Rework* Instruction for PMC2PCI-X, to support PCI-X

* This rework applies to Rev. A and Rev. B

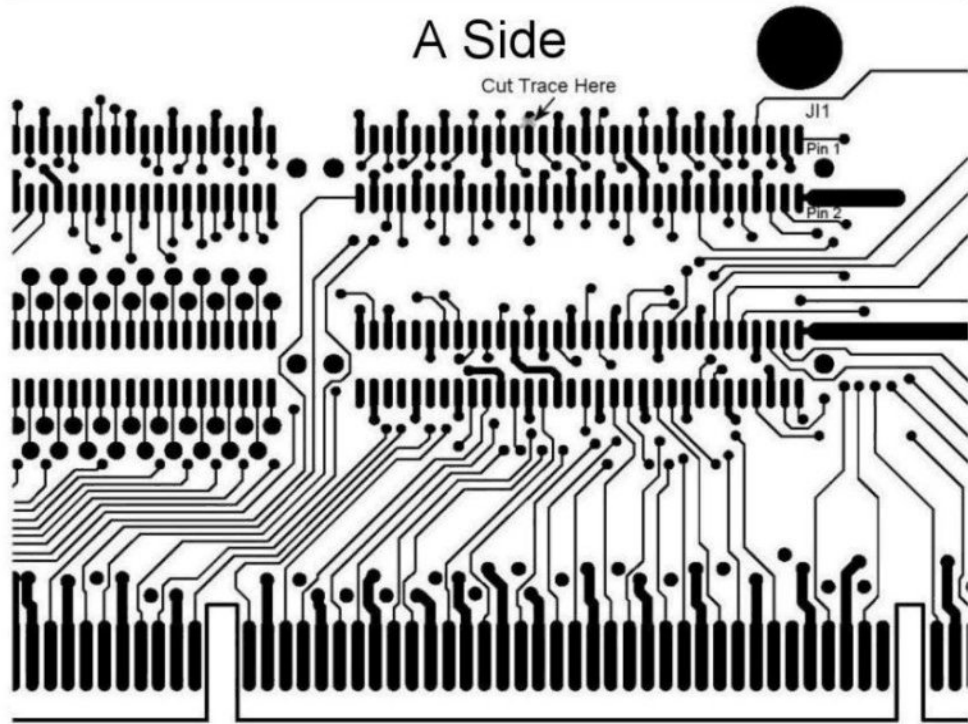
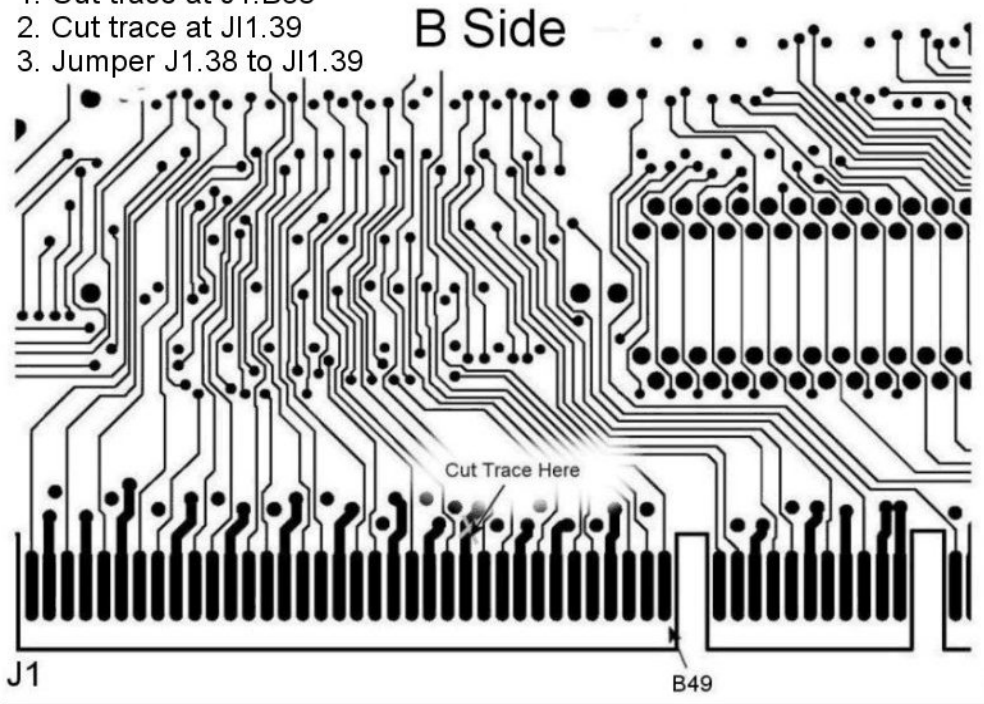
1. Cut trace at J1.B38
2. Cut trace at J11.39
3. Jumper J1.38 to J11.39
